City of Portland, Maine – Building or Use Permit Application 389 Congress Street, 04101, Tel: (207) 874-8703, FAX: 874-8716

Location of Construction: 57 Belfort Street		Owner: Straight Mellissa		Phone: 878-5276		Permit No: 000634	
Owner Address: ***Russell Quinn ***		Lessee/Buyer's Name: ****		Phone: 893-9061**		BusinessName:	
Contractor Name: Russell Quinn		Address:		Phone:		Permit Issued: 2000 JUN 6 10 14 AM CITY OF PORTLAND	
Past Use: RENDER xxxxxxx single family		Proposed Use: same		COST OF WORK: \$18,000		PERMIT FEE: \$132.00	
				FIRE DEPT. <input type="checkbox"/> Approved <input type="checkbox"/> Denied		INSPECTION: Use Group 1.3 Type 5/2 1900899 Signature: <i>[Signature]</i>	
Proposed Project Description: Renovations New second floor over back 1/3 of house				Signature:		Zone: GBL 299-D-021	
				PEDESTRIAN ACTIVITIES DISTRICT (P.A.D.)		Zoning Approval: <i>ok with conditions</i>	
				Action: <input type="checkbox"/> Approved <input type="checkbox"/> Approved with Conditions <input type="checkbox"/> Denied		Special Zone or Reviews: <input type="checkbox"/> Shoreland <input type="checkbox"/> Wetland <input type="checkbox"/> Flood Zone <input type="checkbox"/> Subdivision <in

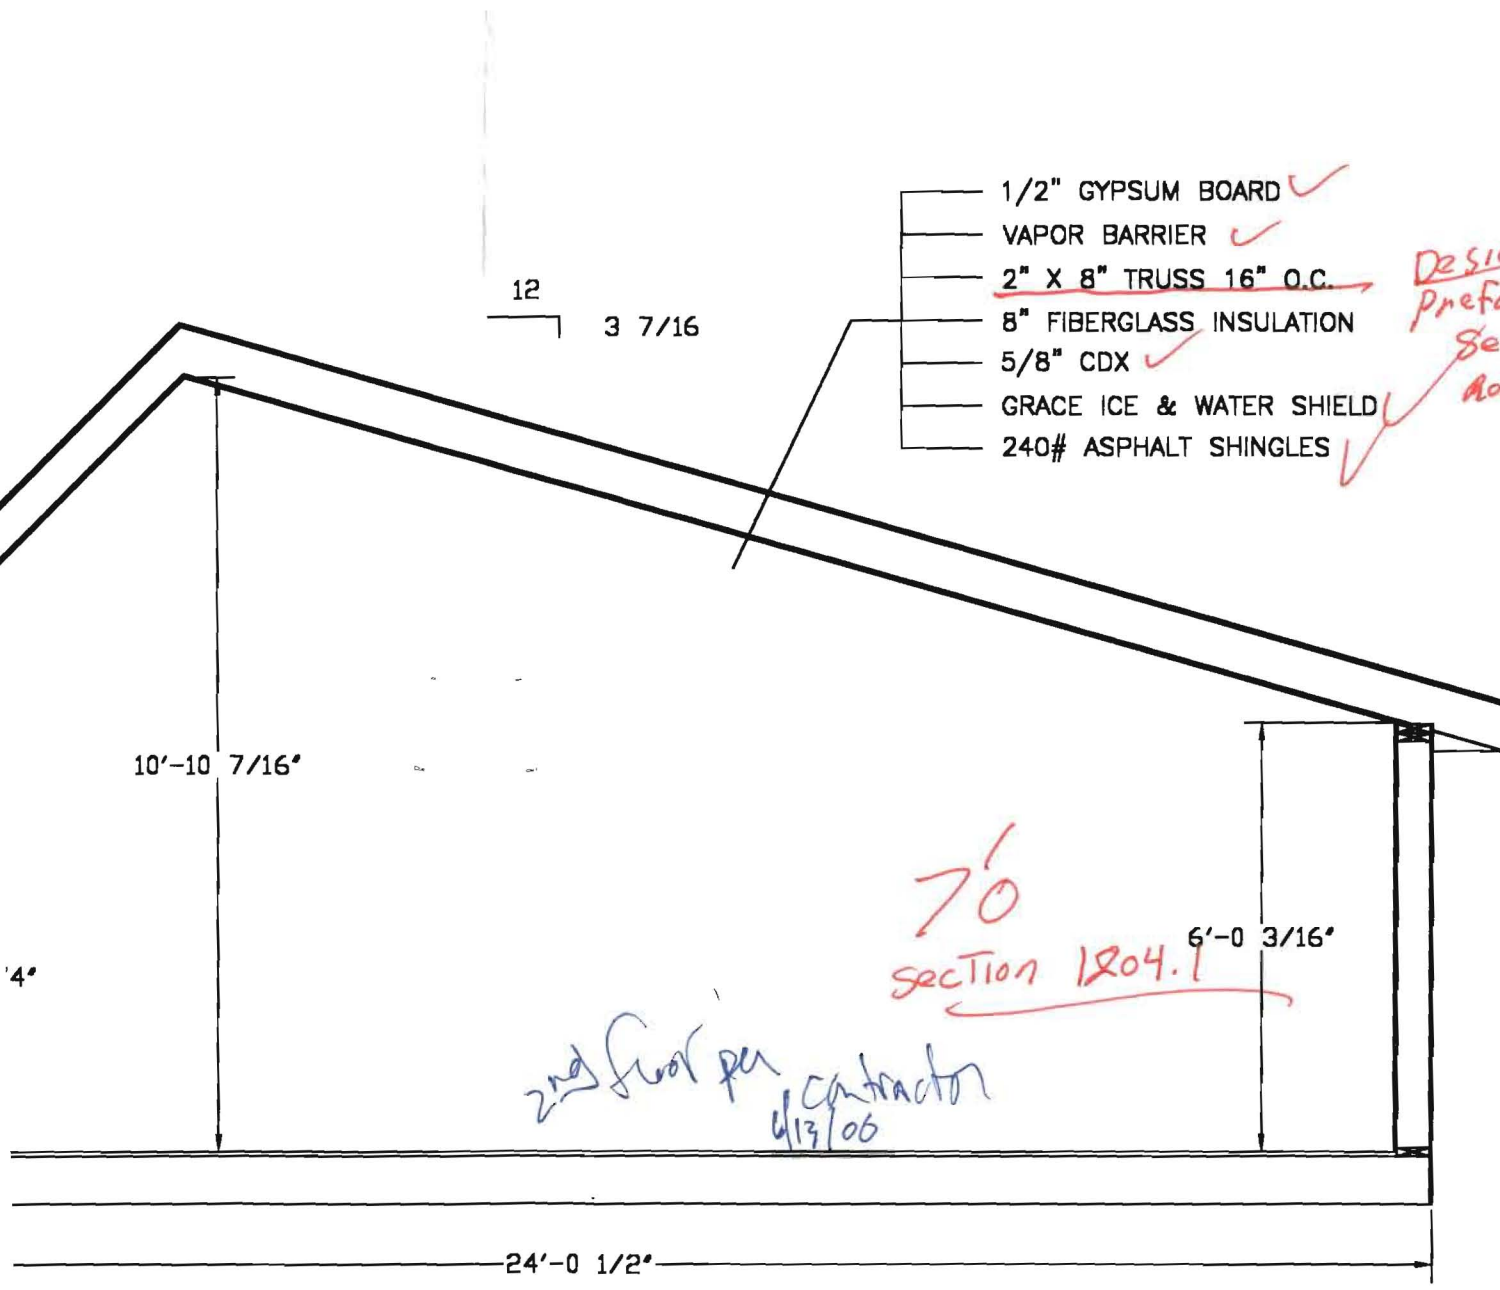
- 1/2" GYPSUM BOARD ✓
- VAPOR BARRIER ✓
- 2" X 8" TRUSS 16" O.C. →
- 8" FIBERGLASS INSULATION
- 5/8" CDX ✓
- GRACE ICE & WATER SHIELD ✓
- 240# ASPHALT SHINGLES ✓

*Design of Truss.
 Prefabricated Components
 Section 2313.0
 Roof Trusses 2313.3*

*70
 section 1204.1*
